**HVAC Replacement for
Summit Drive Elementary School
Greenville County School District**

Solicitation No: **124-33-9-29**

Addendum No. 2

DATE: October 12, 2023

ED-1

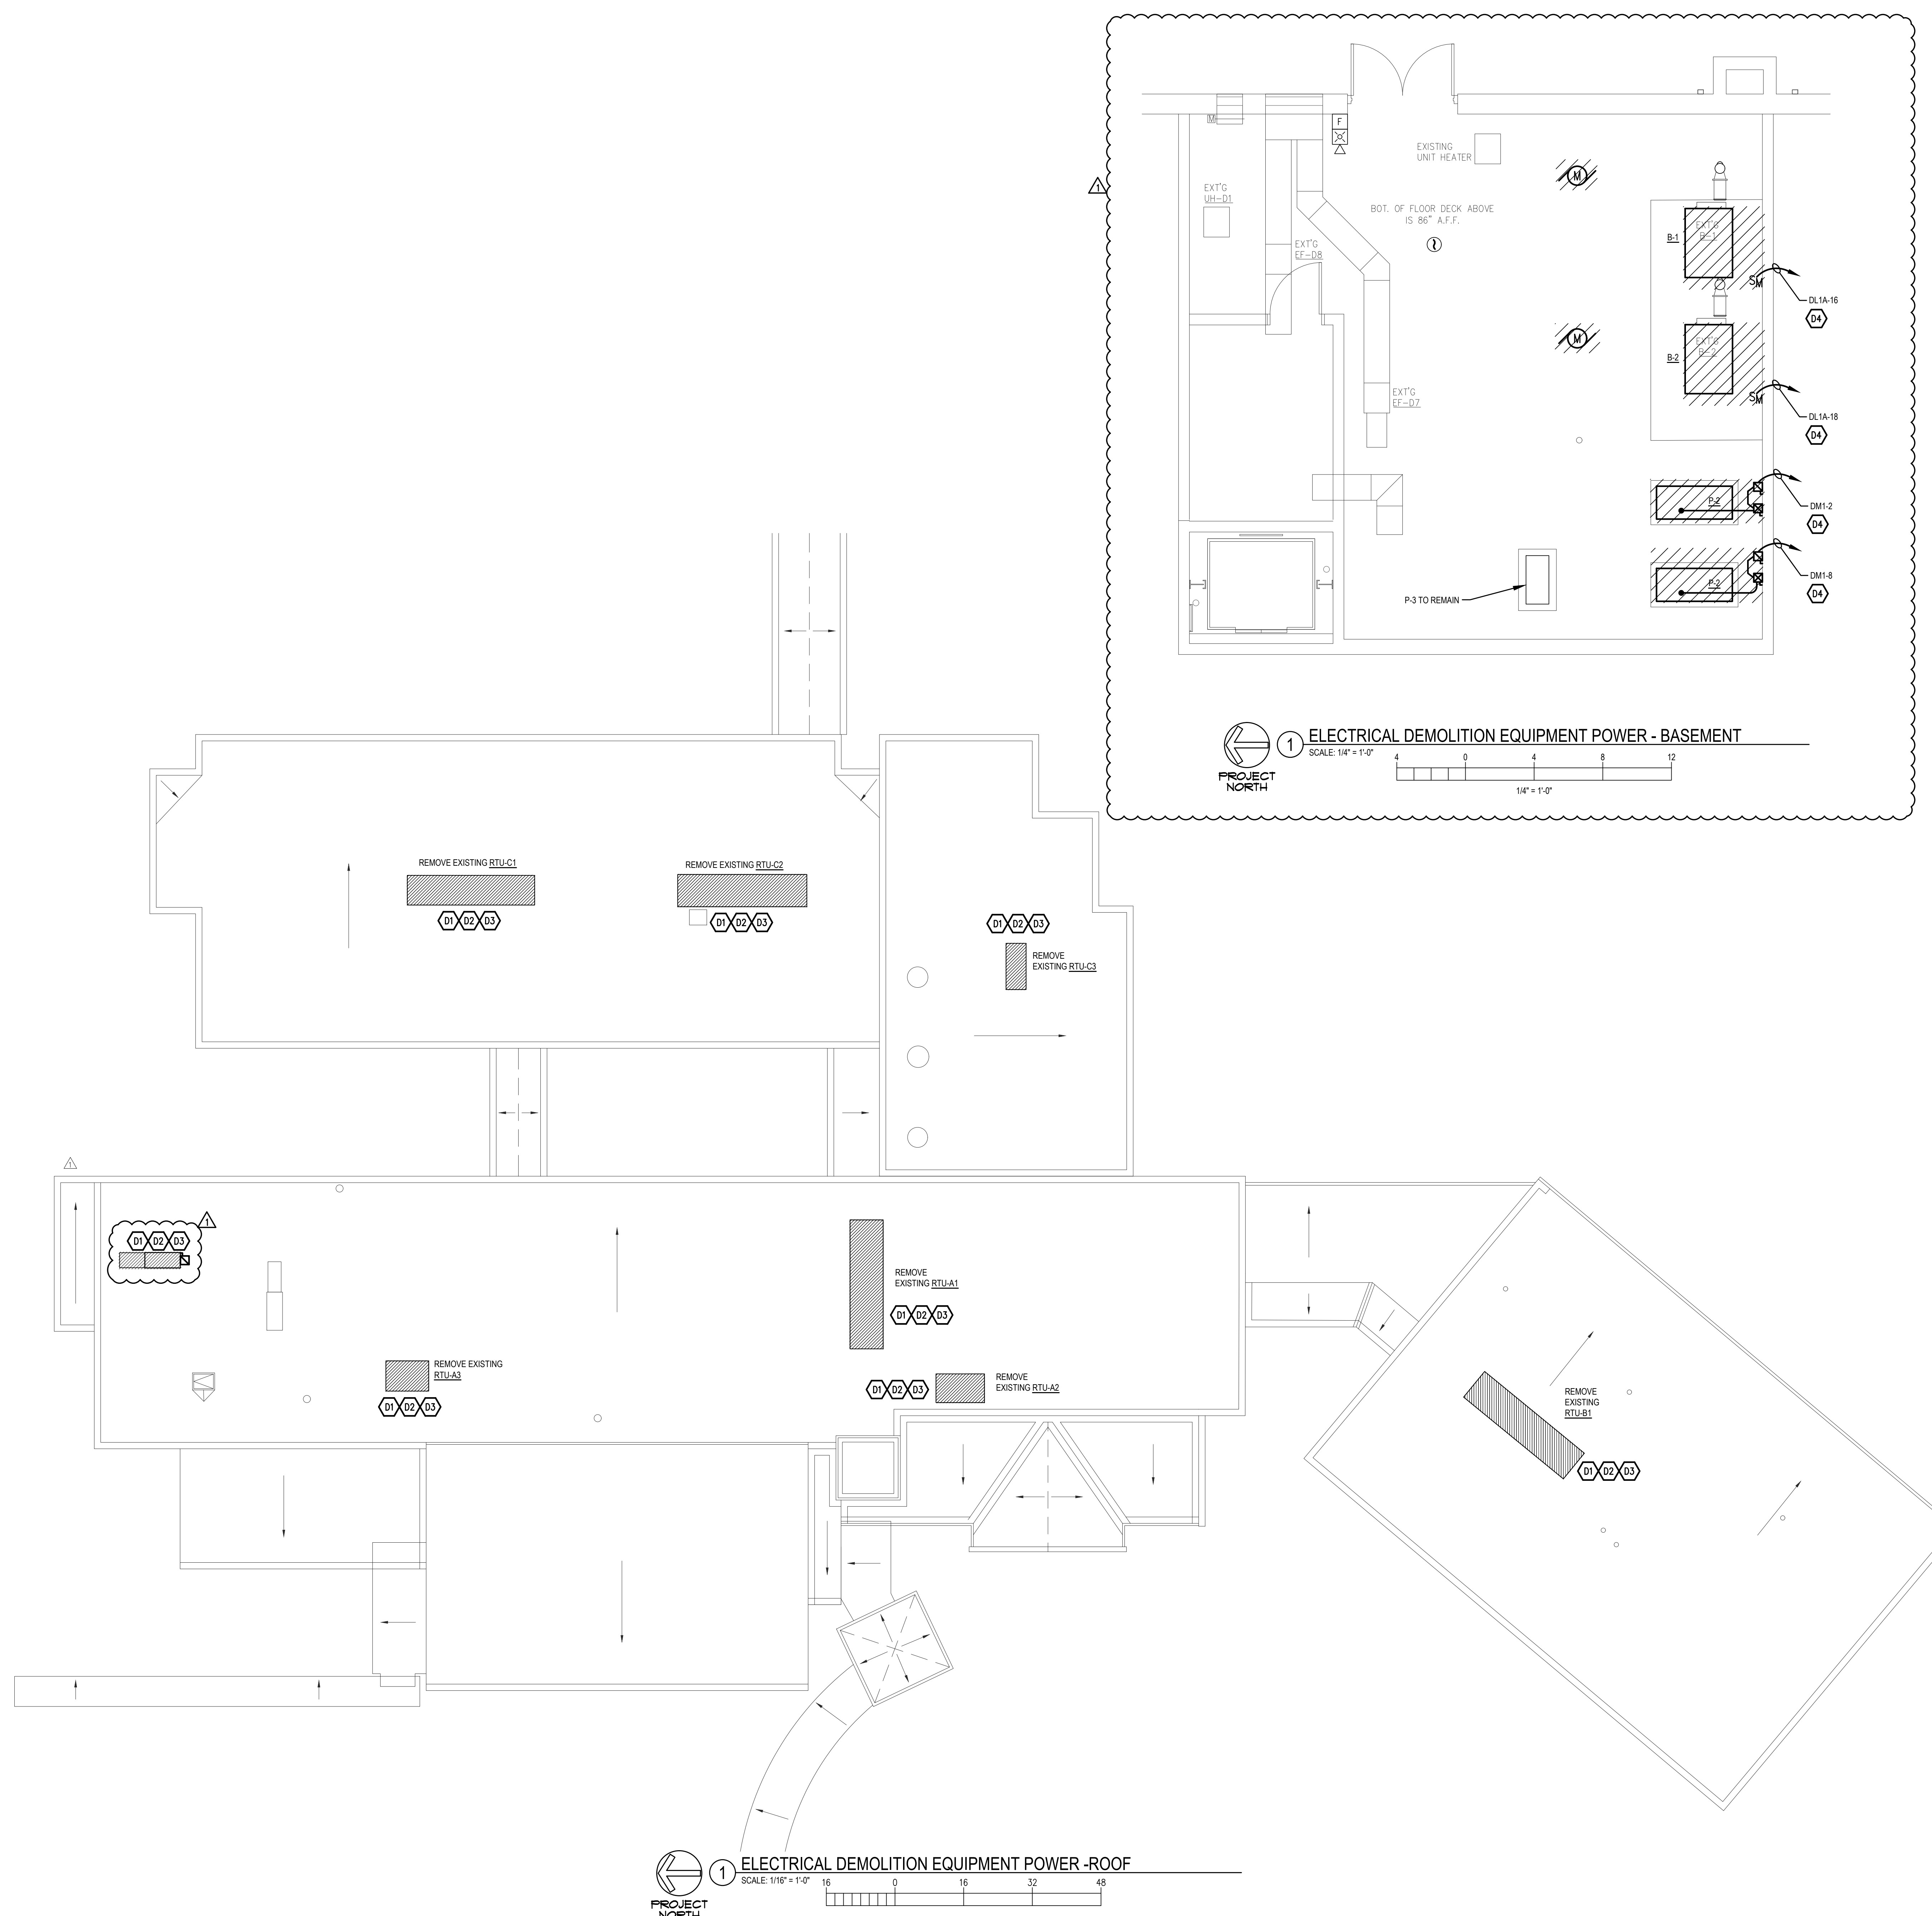
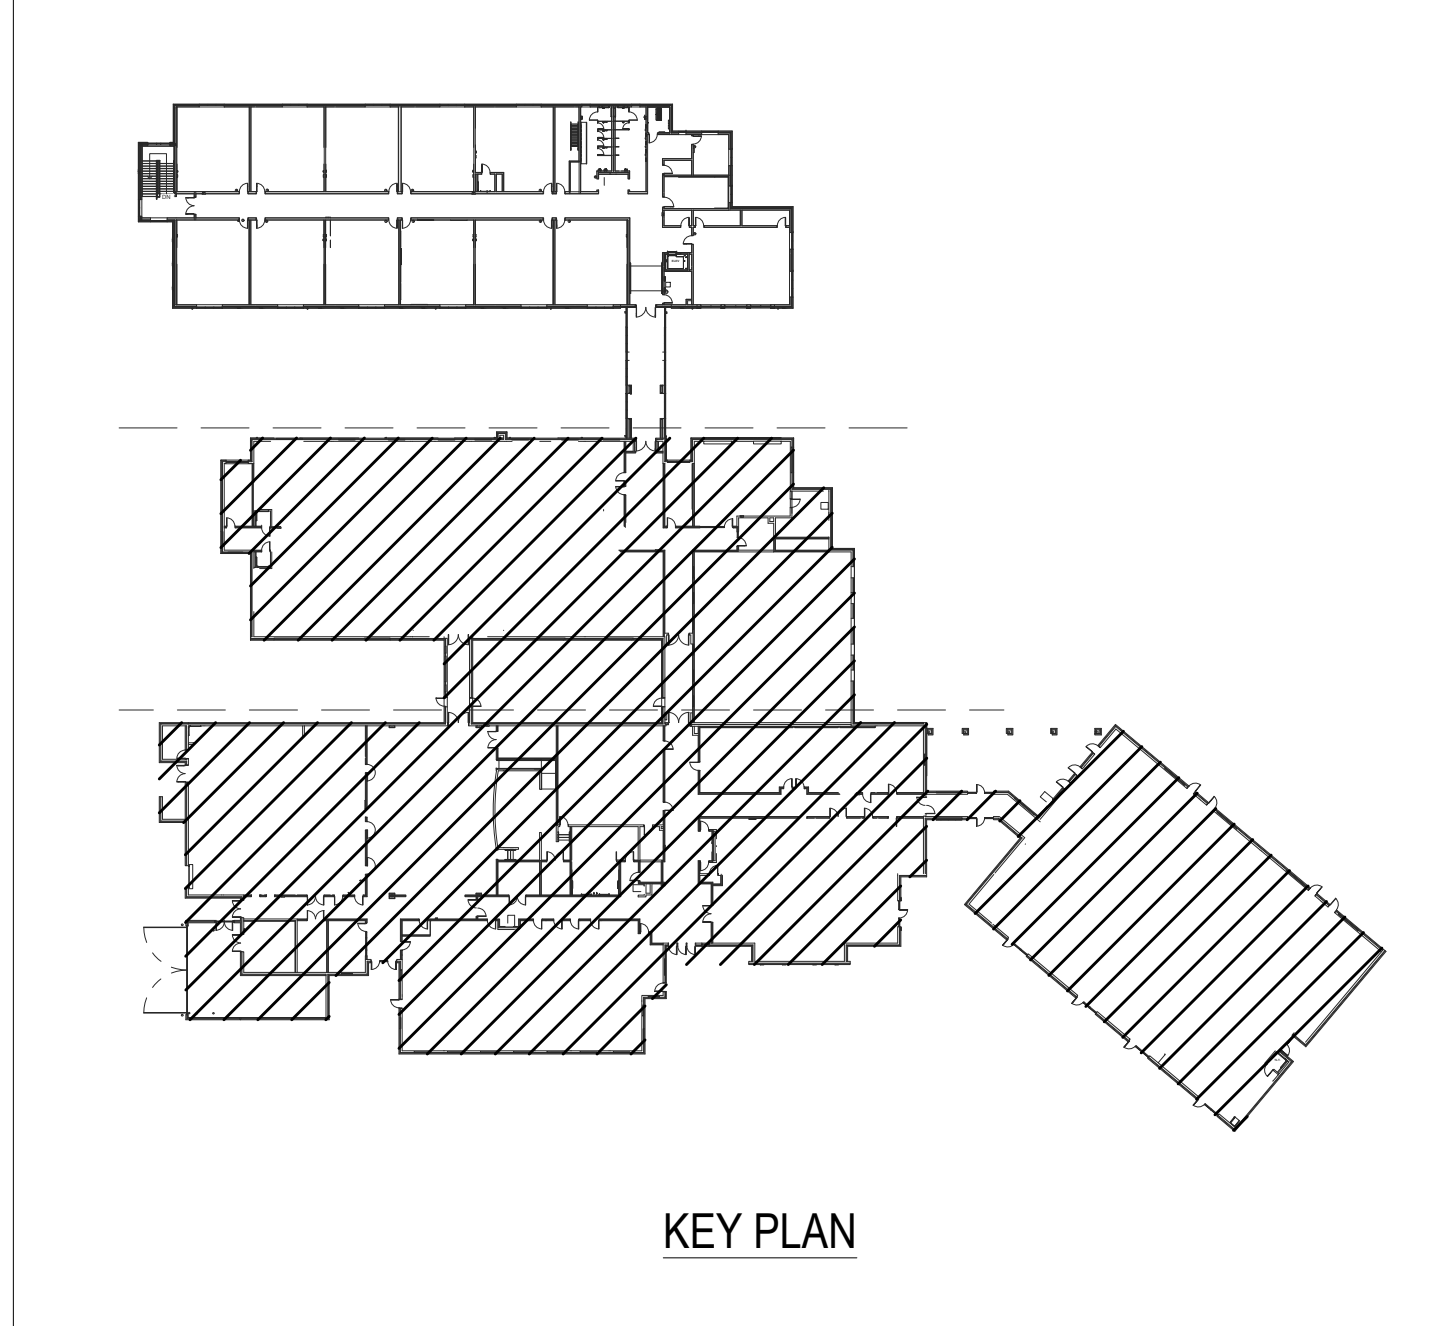
8. ED-1, Electrical Demolition Roof Plan, Added basement demolition plan showing electrical demolition for boilers and pumps being replaced.
